# Safety Policy Division Evaluation Report on PG&E 2024 RAMP Application (A.)24-05-008

November 8, 2024

**California Public  
Utilities Commission**

Figure 10-10: Tranche-level CBR Values for DUNGD-M008<sup>408</sup>

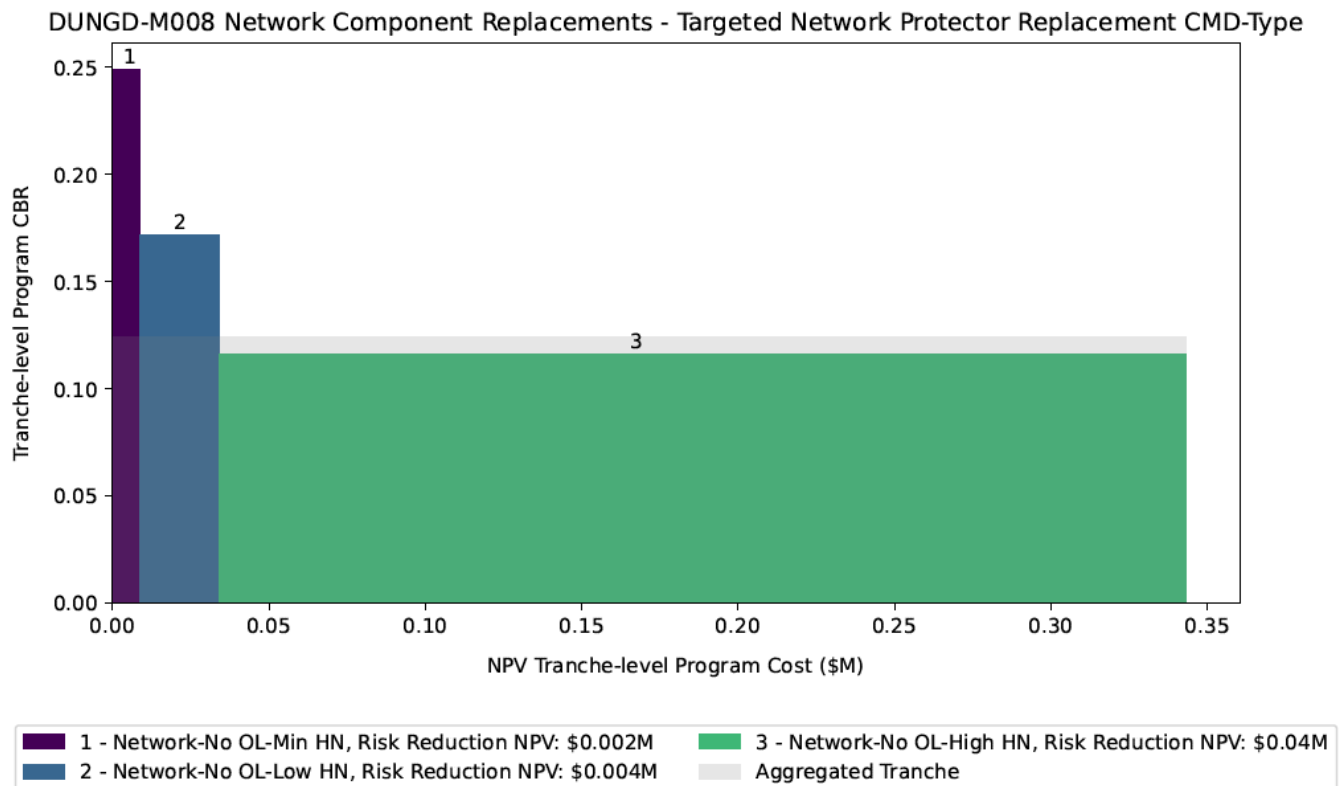
The CBR values for DUNGD-M008 are shown in Figure 10-10. From PG&E’s description of this mitigation program, it is not a compliance-related activity. The CBR for the program is around 0.12, and no

tranche has a CBR greater than 0.25 under this program. Again, these low CBR numbers call into question whether PG&E should implement this mitigation program without providing additional details.

Figure 11-1. Risk Bow Tie<sup>414</sup>

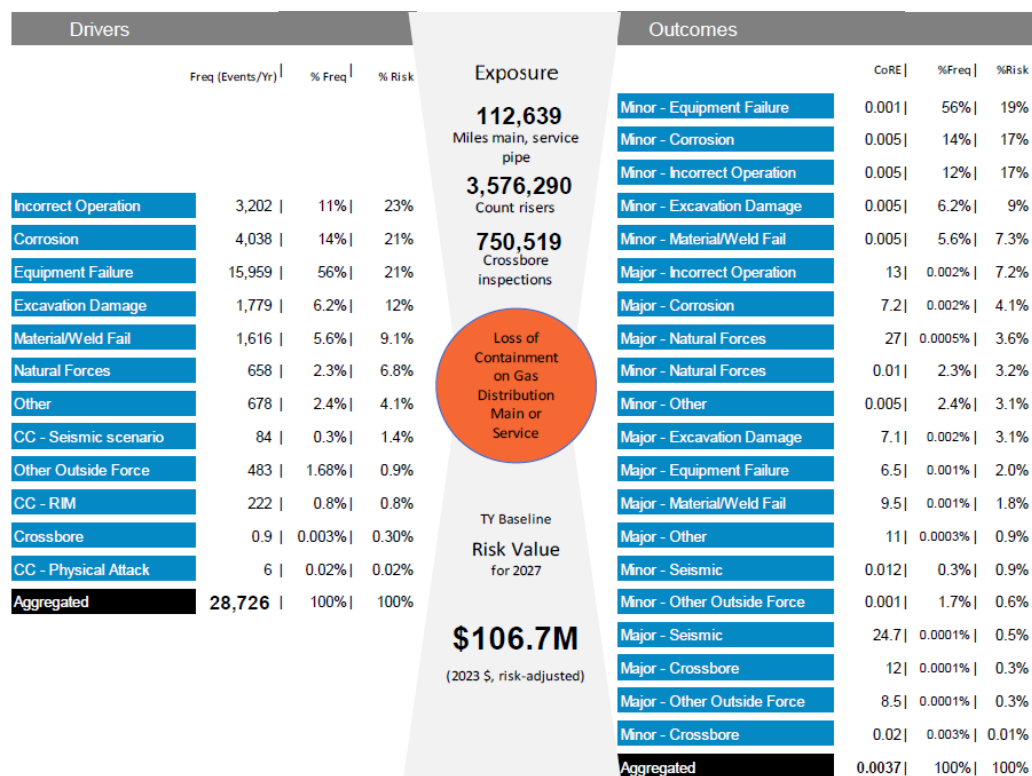
As shown in the Bow Tie (Figure 11-1), the total risk presented by cross-cutting factors is relatively low. The three cross-cutting factors PG&E quantifies in the model comprise approximately 1.1 percent of likelihood and 2.2 percent of the total LOCDM risk value.

appears related to the decision to include non-ignition LOCs in the analysis for this chapter. As shown in the Risk Bow (Figure 11-1), “minor” outcomes account for the vast majority of LOCDM frequency in PG&E’s risk analysis: over 99 percent of LOCDM events. Due to the high frequency, minor LOCDM events contribute over 75 percent of the total risk value of \$106.7 million in PG&E’s risk analysis. However, as shown in Table 11-3, minor outcomes are characterized by having zero safety impact. Furthermore, SPD observes the outsized contribution of the financial attribute risk score from minor events: of the \$81.4 million risk score from LOCDM events categorized as “minor,” \$76.5 million is from financial consequences. These two factors, combined with the previously described high relative frequency of minor LOCDM events, results in an analysis that weighs against safety considerations and favors reducing financial impacts associated with leak repair when determining appropriate controls and mitigations.

Figure 12-1: Risk Bow Tie

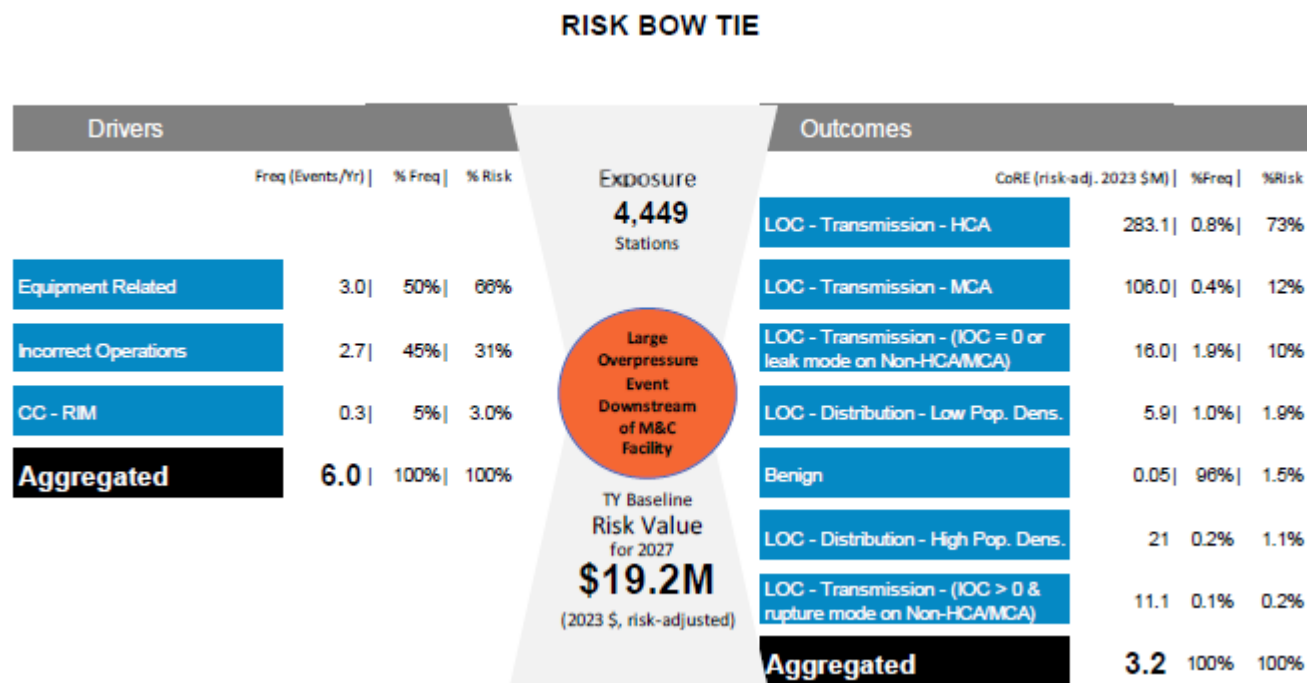
SPD agrees with PG&E’s justification for increasing the number of outcomes from the 2020 RAMP. Separating the outcomes to align closely with different downstream pipelines will help quantify the consequences, frequency of outcomes, and risks more accurately.

**Figure 2** - PG&E's risk multipliers for different levels of consequence. Categories are Retention (<\$100m), Insurance-based (\$100m-\$1b), and Catastrophic (>\$1b).<sup>26</sup>

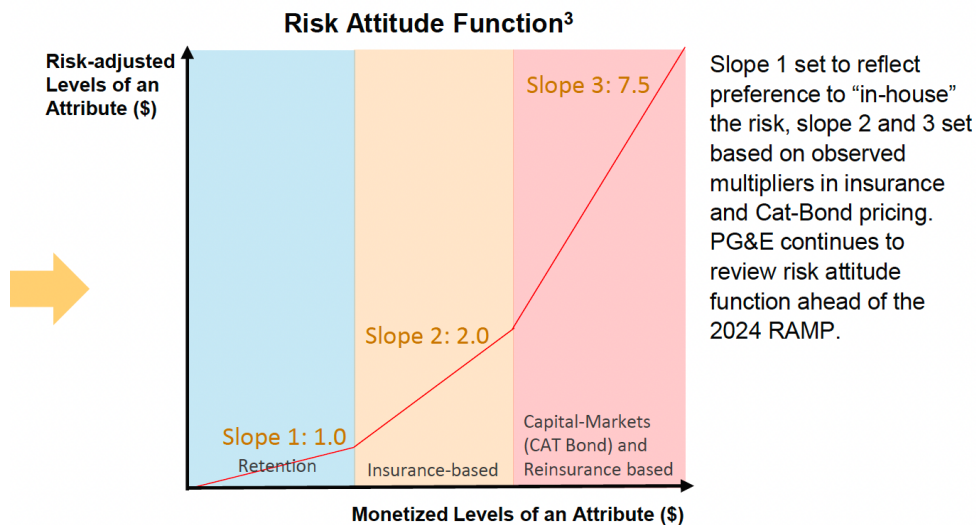
As seen in Figure 2, PG&E’s risk function uses a multiplier for each attribute level. PG&E’s method for obtaining its Catastrophic multiplier “*is to use available, objective data to determine the Risk Scaling Function(s). Risk Premiums/Prices from Insurance and Capital Markets meet these*

**Figure 4** - Cost per avoided PSPS minute for each grid segment in the PG&E 2023 undergrounding program. The scale is logarithmic.

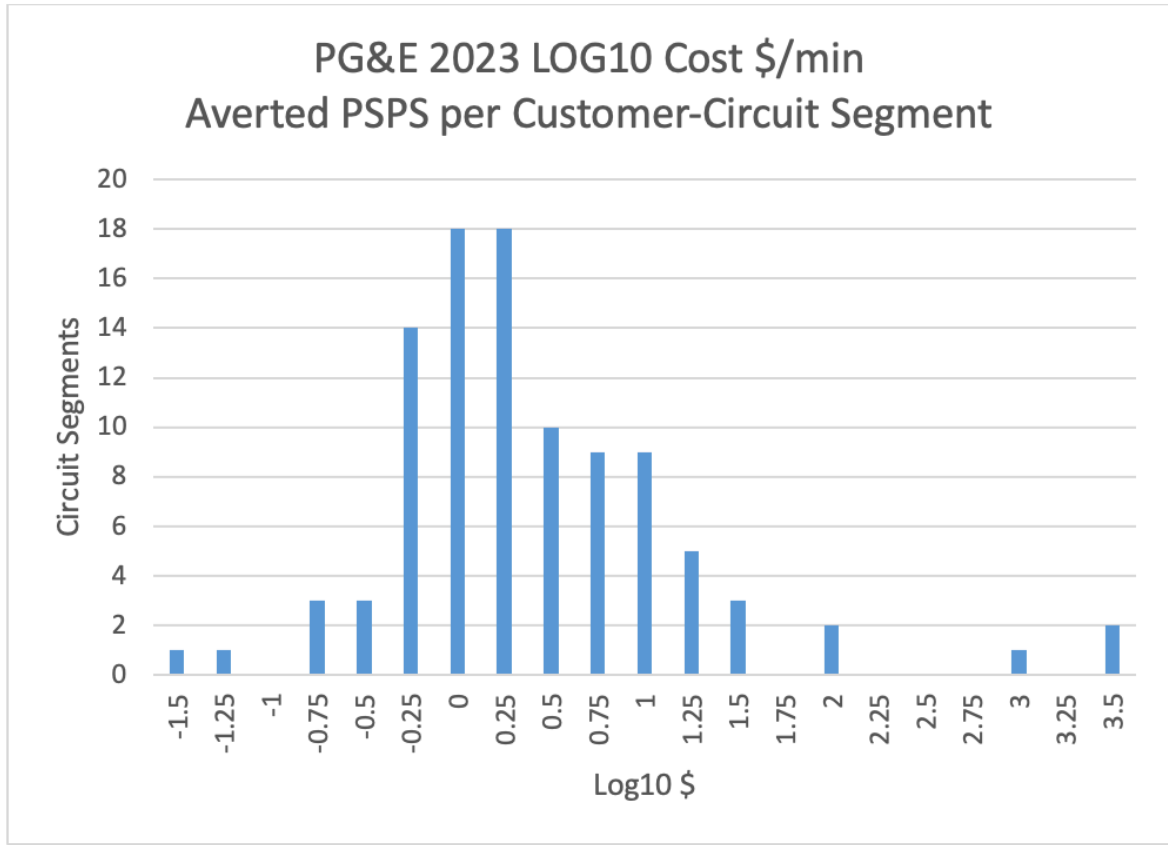
The scale in Figure 4 is logarithmic, and the range varies by 5 orders of magnitude (a factor of 100,000). The majority of circuits fall between \$1 and \$10 per minute of avoided outage per customer per year. The cost per CMI calculated by the ICE model is \$3.17,<sup>69</sup> which seems to imply that undergrounding is a cost-efficient selection for a good fraction of the circuits. However, as noted in Section 2.2.2, the ICE model results entirely dominated by medium and large commercial customers, which cost \$78 per CMI, and small commercial customers which cost \$9.99 per CMI. Residential customers are estimated to cost only \$0.06 per CMI. This analysis does not take the variations in segment by segment customer makeup. However, on circuits that serve very few customers, often in highly rural areas, it is more frequent than not only residential customers will be on the circuit, therefore making the argument for undergrounding significantly less tenable. Table 1 shows that for circuit segments without medium or large business the CMI is only \$0.68

(=\$97k/\$142k) in PG&E's HFRA. Applying this to Figure 4 would reduce the values in the x axis by a factor of 4.6 (= \$3.17/\$0.68).

**Figure 6** - PG&E Figure 1-2,<sup>75</sup> showing baseline and residual total risk with and without mitigation. PSPS and EPSS can be seen to make up the majority of the residual risk.

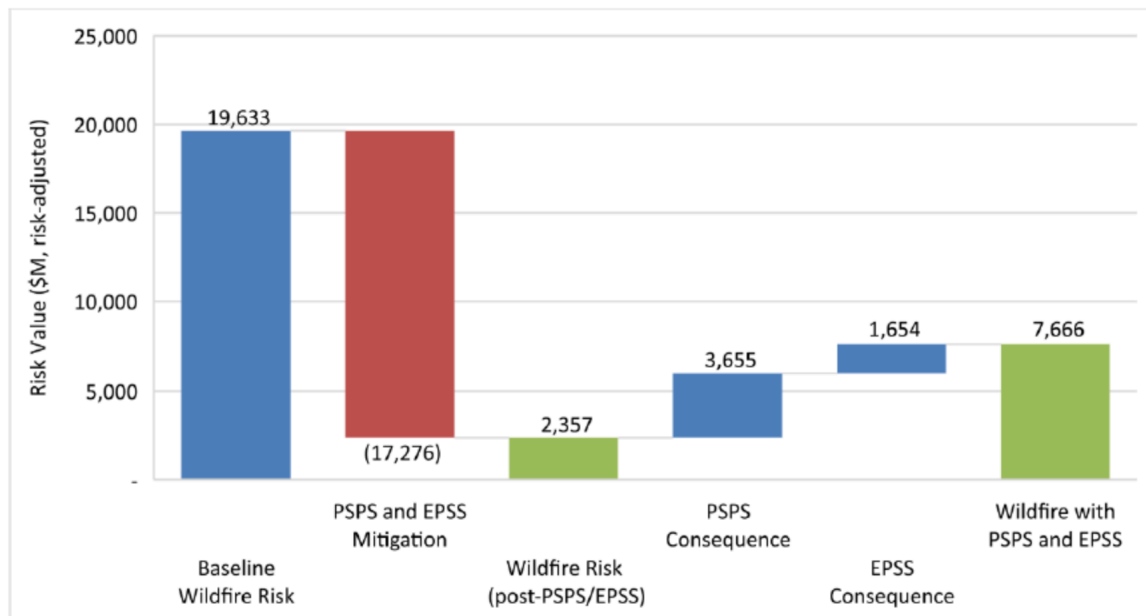
As shown in PG&E's Figure 1-2, EPSS consequences make up 21 percent of its total residual risk after mitigation.

**Figure 7** - PG&E Figure 1-3, showing baseline and residual total safety risk with and without mitigation.<sup>76</sup>

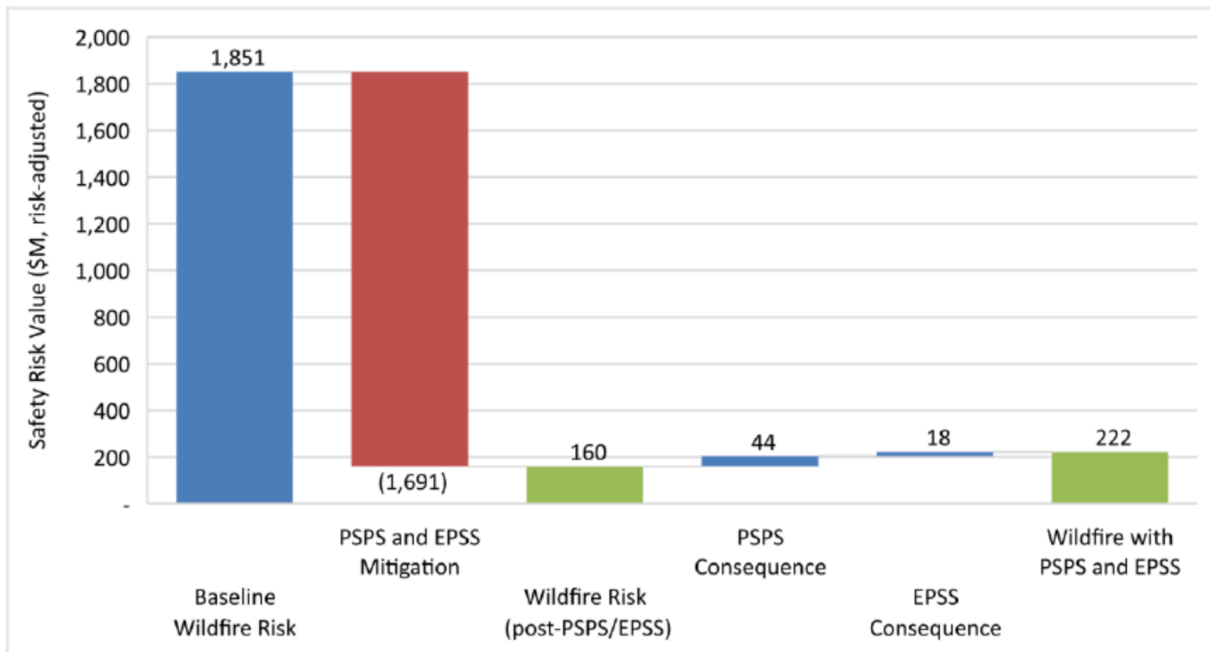
According to PG&E, PSPS and EPSS consequence risks correspond mostly to reliability and financial risks, as comparison between PG&E's Figure 1-3 and 1-2 shows that safety risk from PSPS and EPSS total only about 1% of the size of the other consequences of EPSS and PSPS (reliability and financial).

**Figure 11** - For each value of MGRA's fire weather metric, the fraction of events classified by FPI ranking is shown.

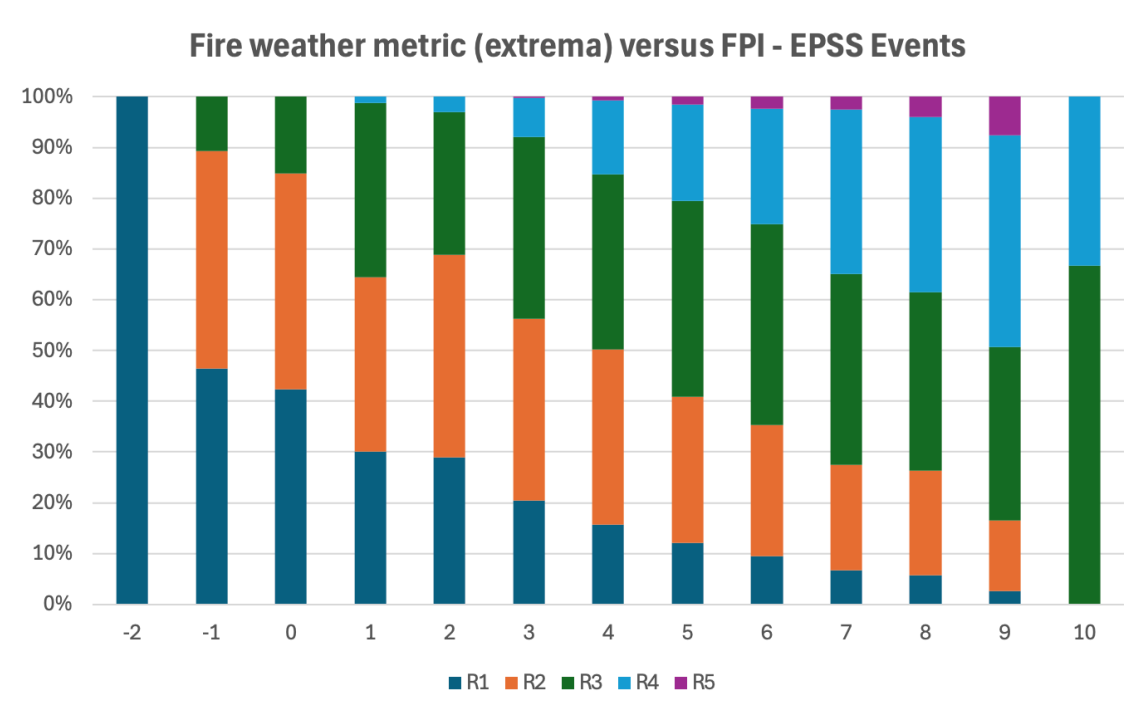
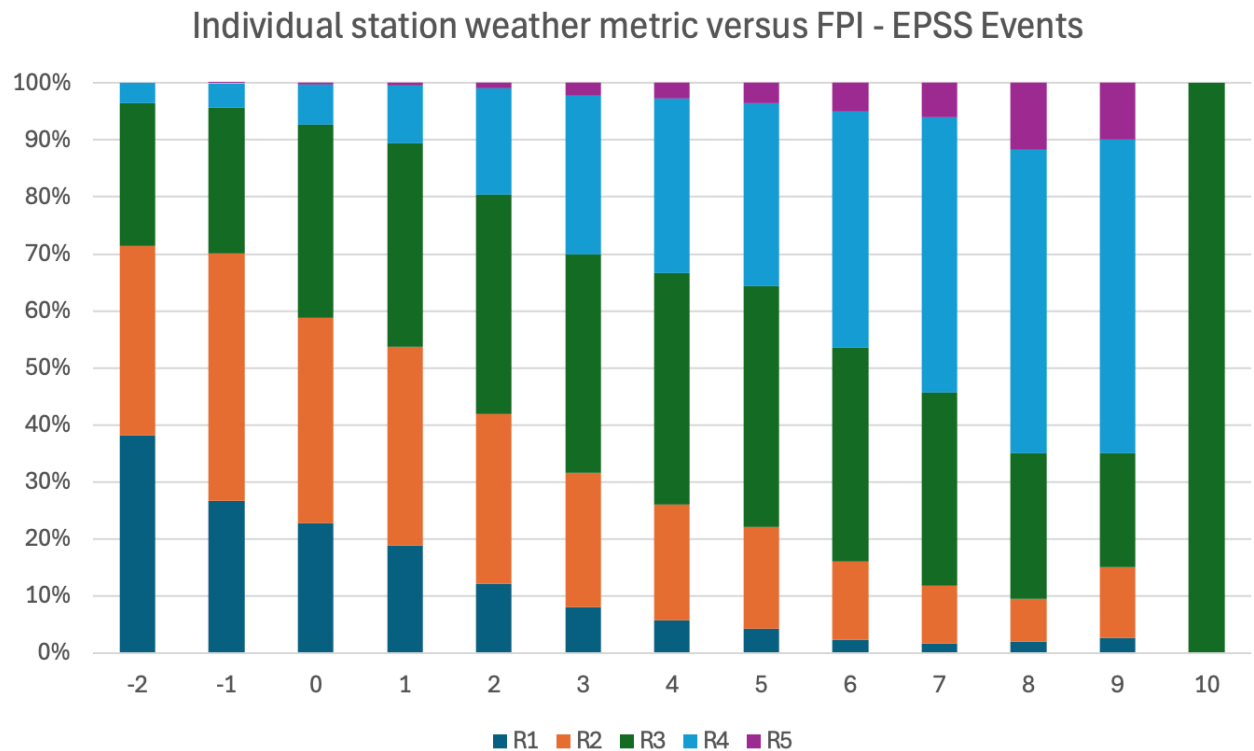
In general form, Figure 11 and Figure 13 are very similar: both the extrema weather metrics and the individual station weather metrics show a clear correlation with FPI. The extrema weather metrics show a larger fraction of R1 and R2 FPI levels, but even for individual weather stations over 10% of moderate to severe weather measurements (MGRA metric >5, for instance a RH of 15%, temperature of 85 degrees F, and wind gust of 18 mph would be a 6) that could propagate a wildfire under dry fuel conditions.

*Figure 6. PG&E Modeling of Baseline Wildfire Risk and Impact of Climate Change*

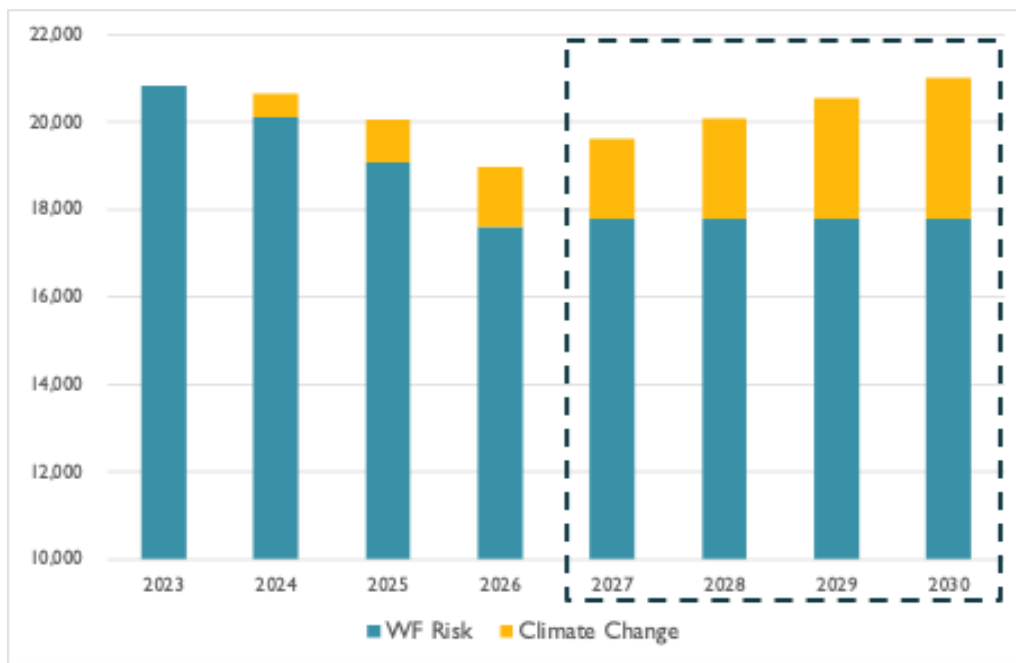
Incorporating climate change has a significant impact on total wildfire risk, comprising 9% of baseline wildfire risk in 2027 to 15% of baseline risk in 2030. Baseline wildfire risk increases by 18% due to climate change from 2023 to 2030.<sup>59</sup>

*Figure 9. Alternative Estimate of Annual Impact of Climate Change on Baseline Wildfire Risk Score (Risk Units)<sup>66</sup>*

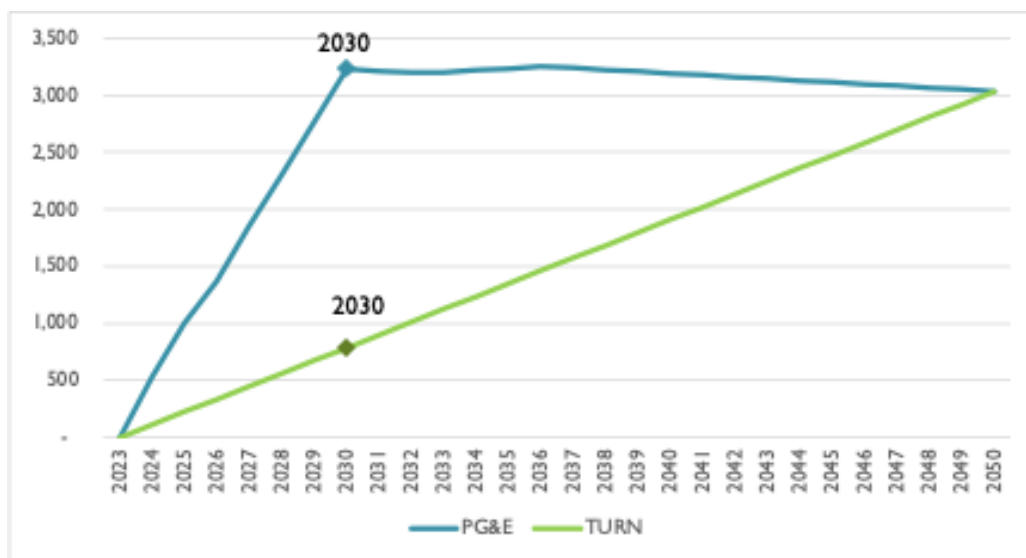
TURN here offers an alternative approach based on the ICF data used by PG&E. Rather than utilizing results whereby all of climate change impacts' affect only the 2023-2030 time period, PG&E could incorporate a smoothed average estimate of climate change's annual impact based on ICF's results. To accomplish this, we calculate the average impact from 2023-2050 and then set this as the annual incremental amount by which climate change increases the baseline risk score. This approach would allow PG&E to incorporate a more gradual annual increase to the wildfire baseline risk score due to climate change while the Commission and parties explore the topic through a more robust process.
